DRAFT
Environmental Impact Statement

Appendix 17B

Supplemental PCN Information

The Belleayre Resort at Catskill Park

WATER
TREATMENT
PLANT
LOCATION
MAP

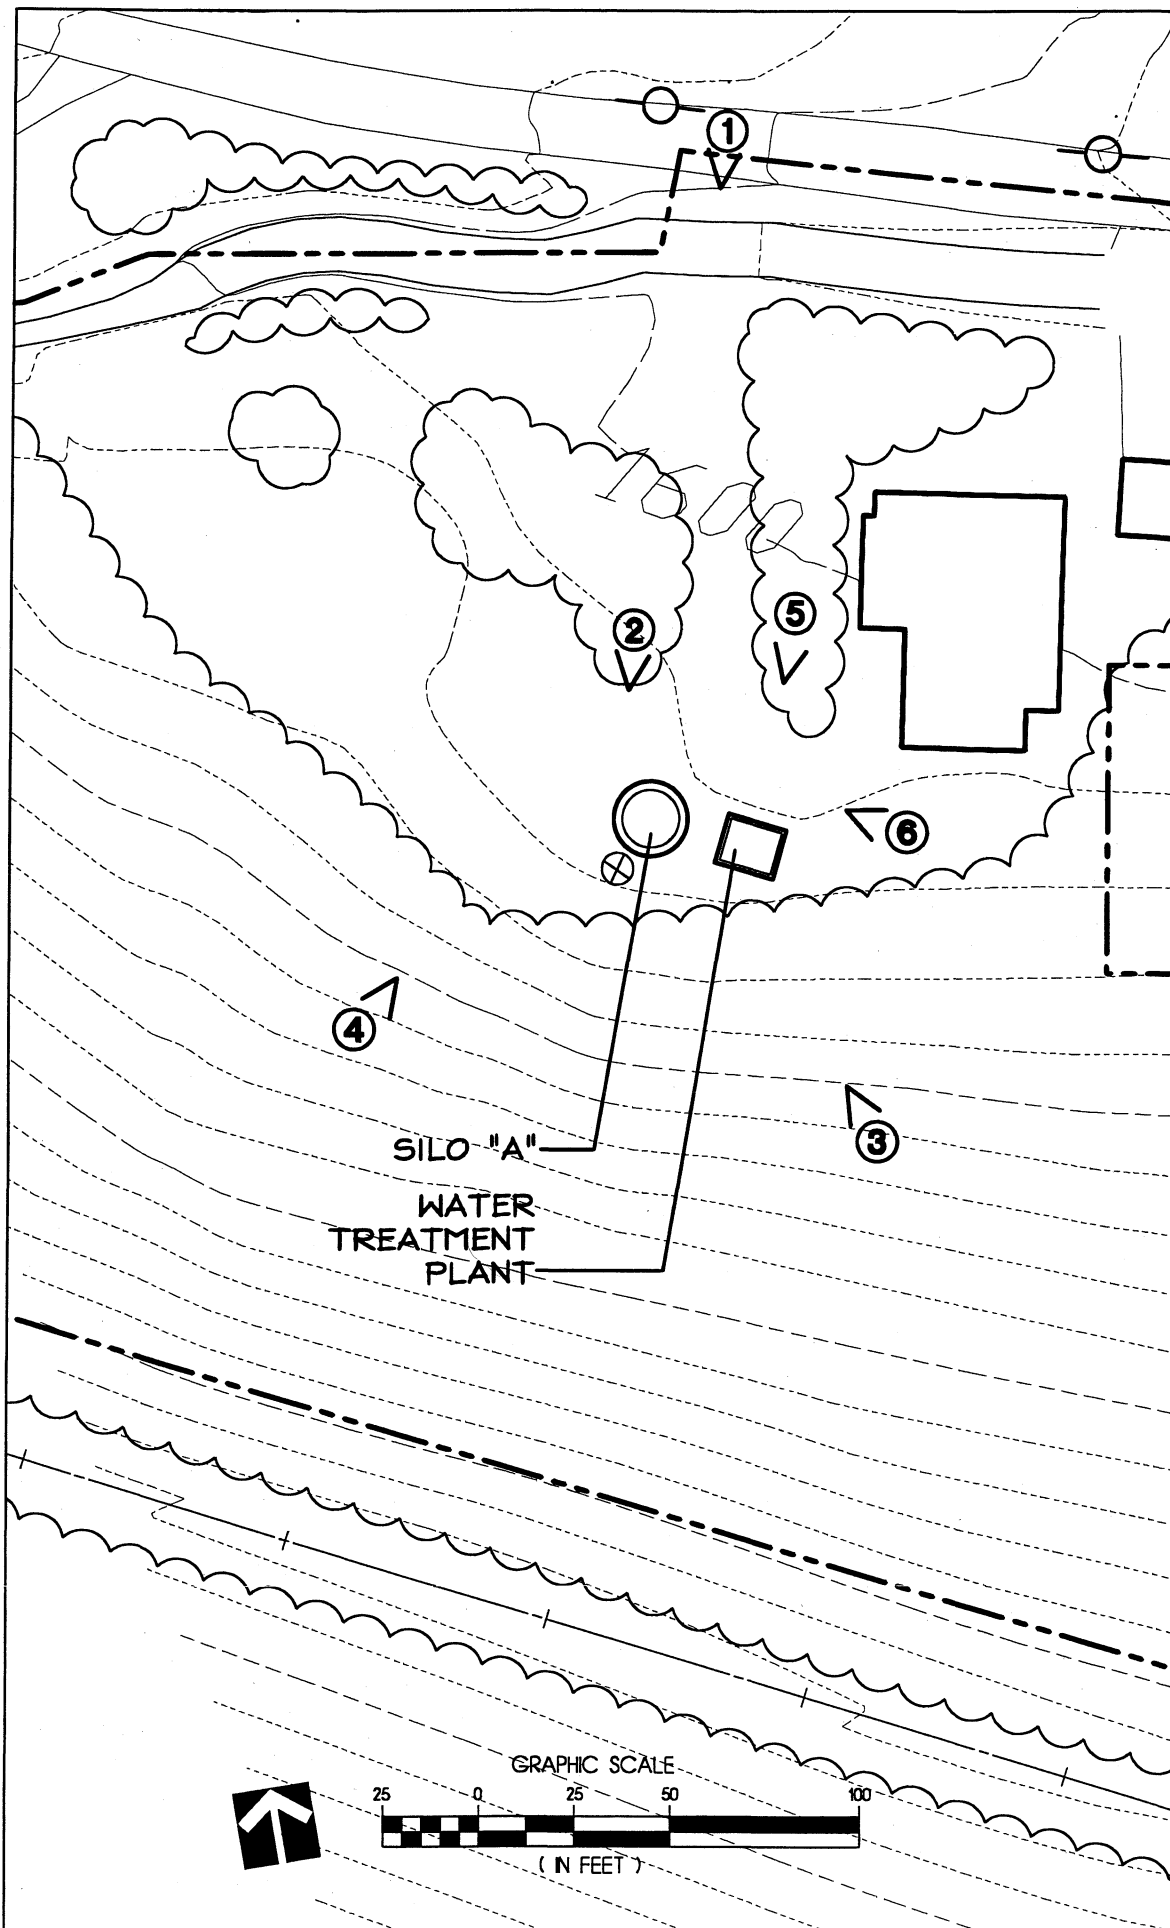
Attached as per your request are sets of numbered photographs keyed to 50 scale drawings of the areas around the western water treatment plant (Silo A) as well as the Winding Mountain Road Bridge on MP-4.

There are no wetlands in the vicinity of the water treatment plant.

WINDING
MOUNTAIN
ROAD BRIDGE
PHOTO
LOCATION
MAP

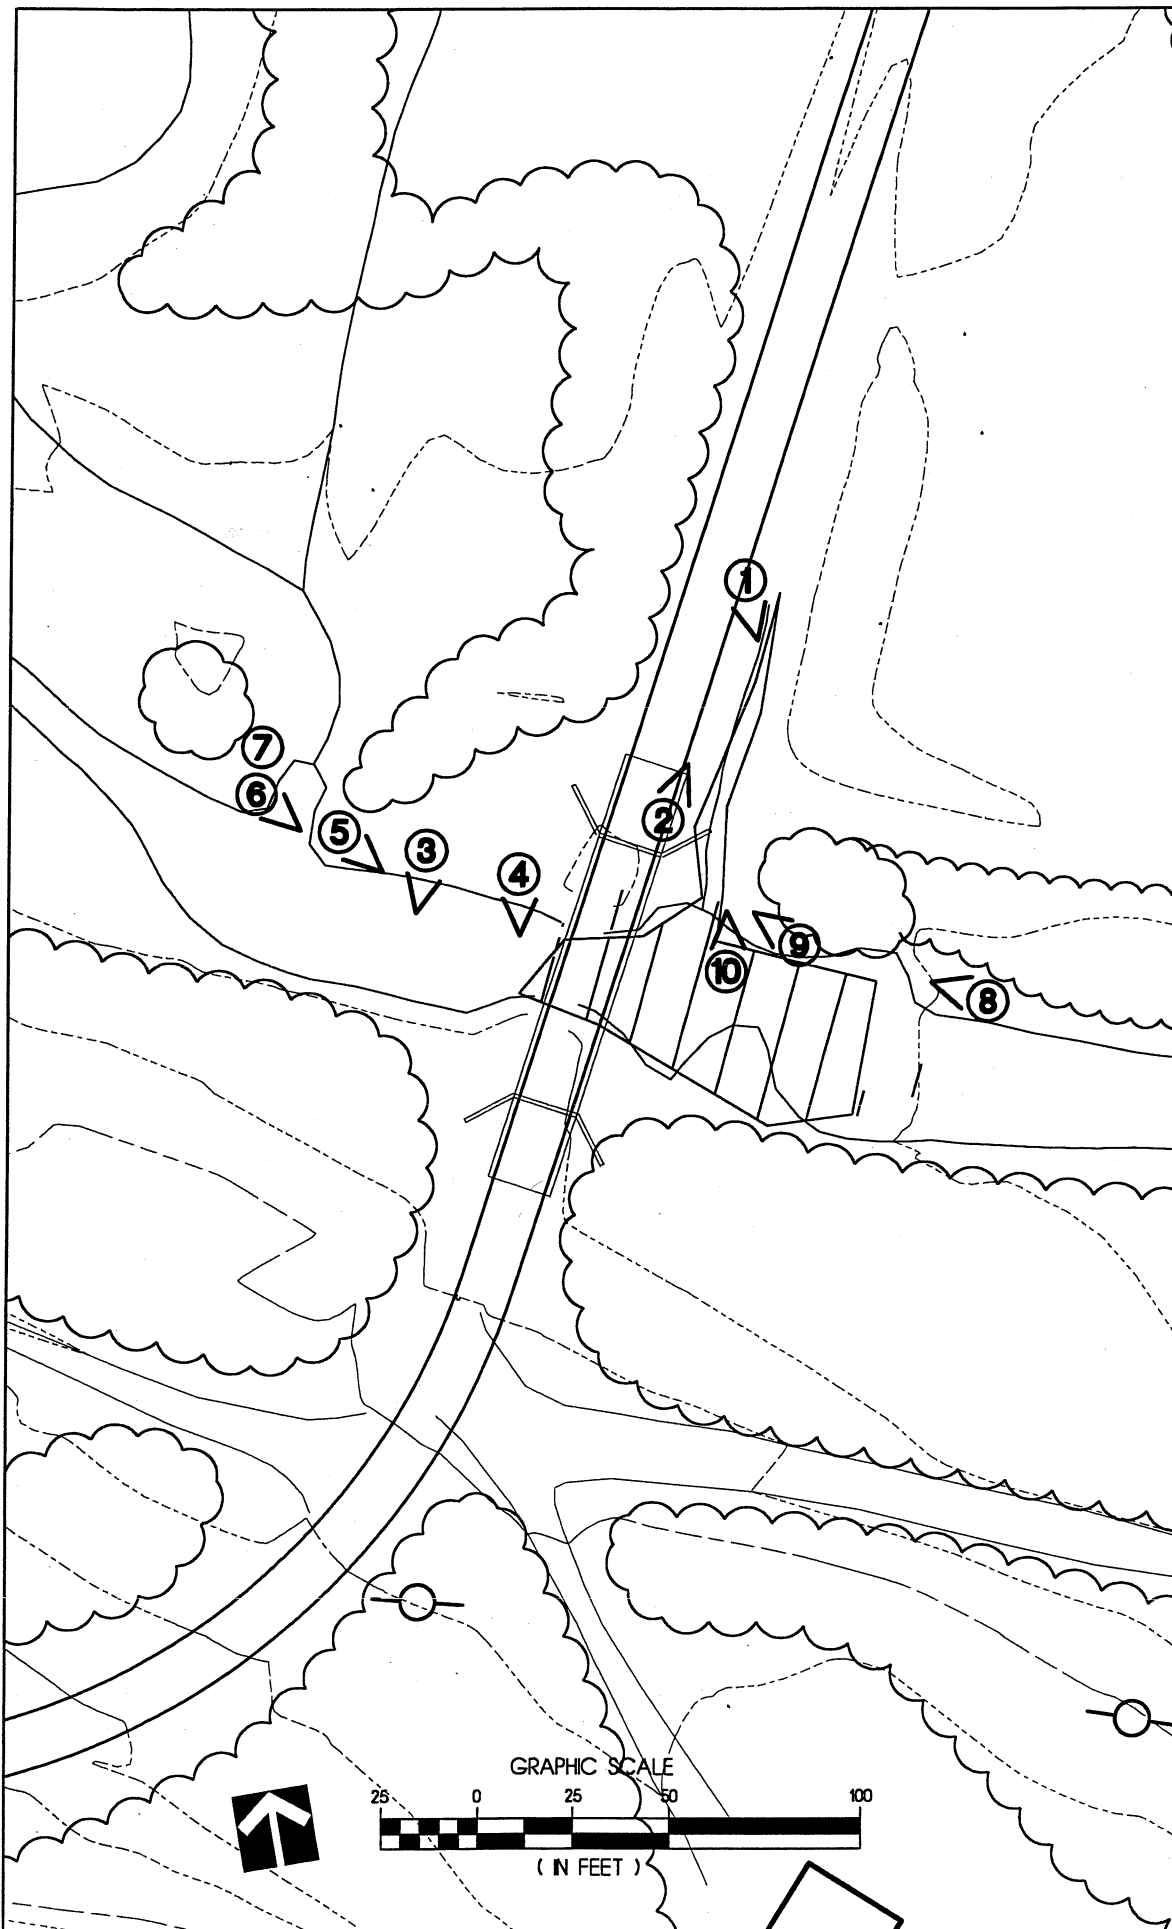
Birch Creek and the roadside ditch wetland along Winding Mountain Road are shown in these photos.

As per item 2 above, photos of the Winding Mountain Road bridge area keyed to a 50 scale map are enclosed. Photos 1 and 2 best illustrate the area of proposed wetland fill.

BIG INDIAN PLATEAU / BELLEA YRE HIGHLANDS
 WATER SYSTEM

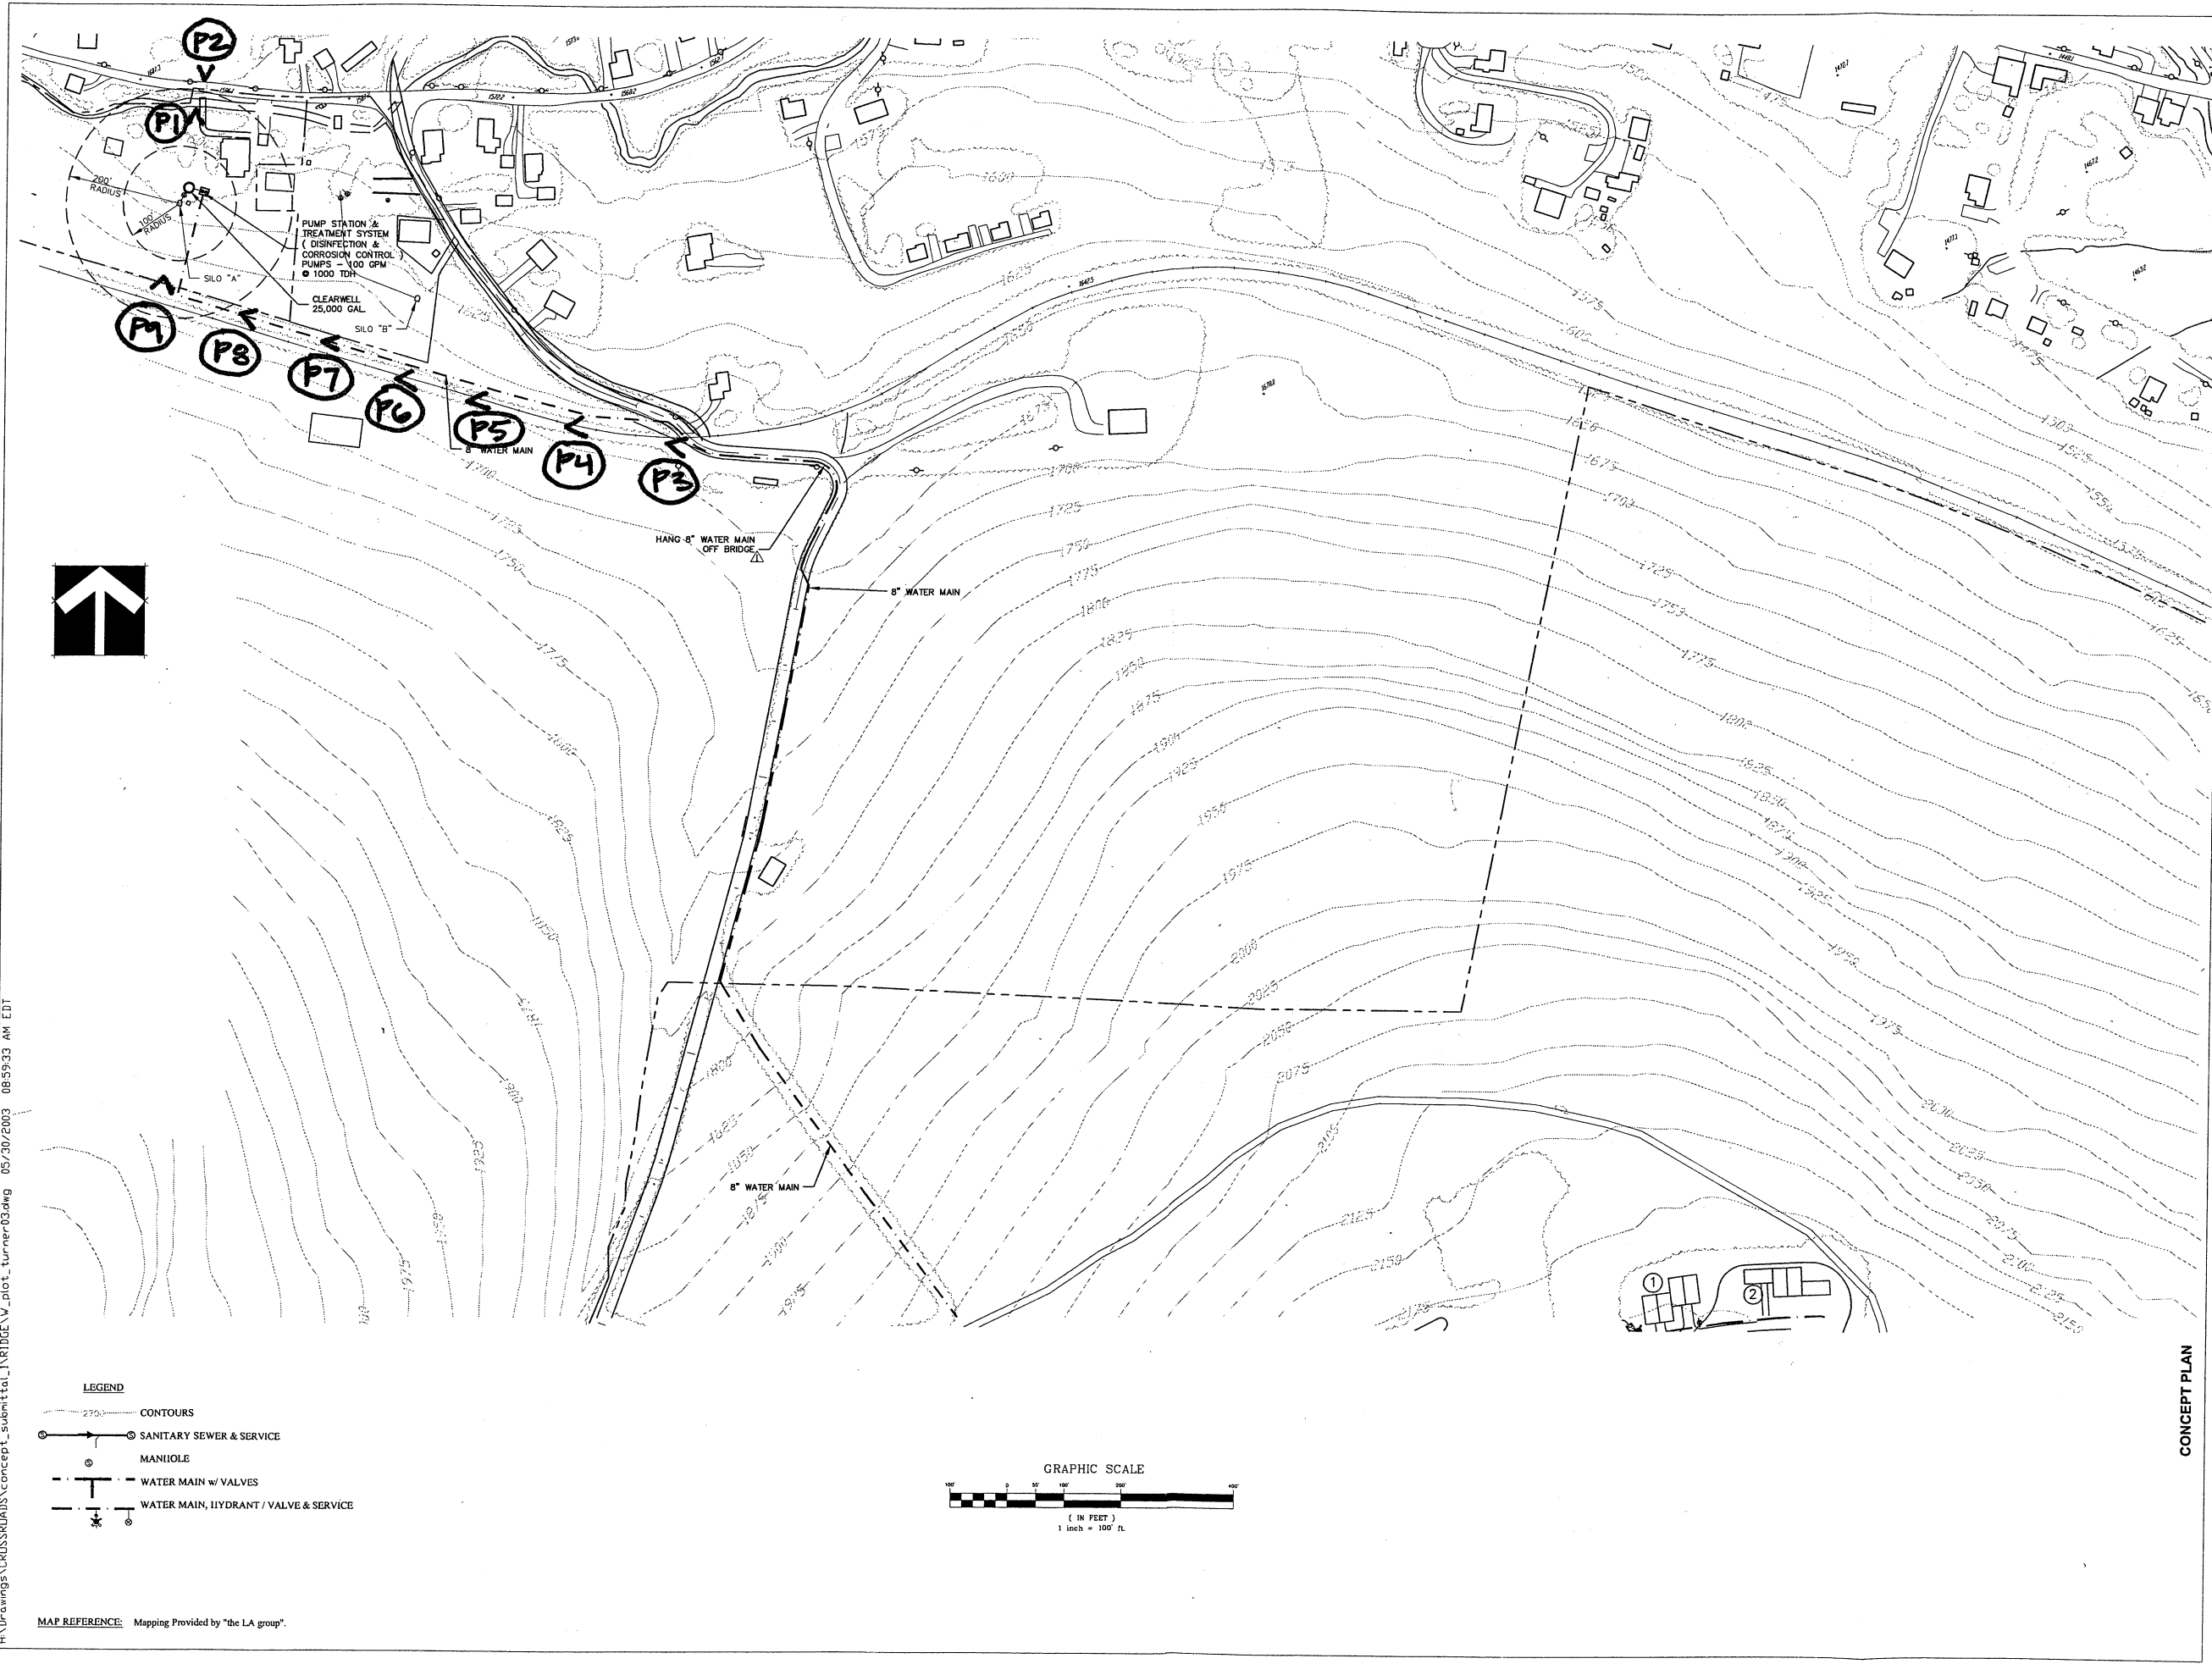
Enclosed is a copy of Delaware Engineering Sheet 3, "Big Indian Plateau/Belleayre Highlands Water System". This Sheet shows the water main from Silo "A" running uphill to the south to a point where it intersects the abandoned railroad tracks. (The unnamed tributary to Birch Creek is to the north of Silo "A".) The water main then runs along the railroad tracks for a distance of approximately 900 feet. The enclosed photos 3 through 9 were taken along the route of the water main and the railroad tracks. Photo locations are shown on Sheet 3. The water main will then be installed under Woodchuck Hollow Road, including a bridge attachment where the road crosses over the brook in Woodchuck Hollow. The water line is then brought into the project site from Woodchuck Hollow Road underneath the existing overhead utility lines. No wetlands or waters of the US are present along the overhead utility lines.
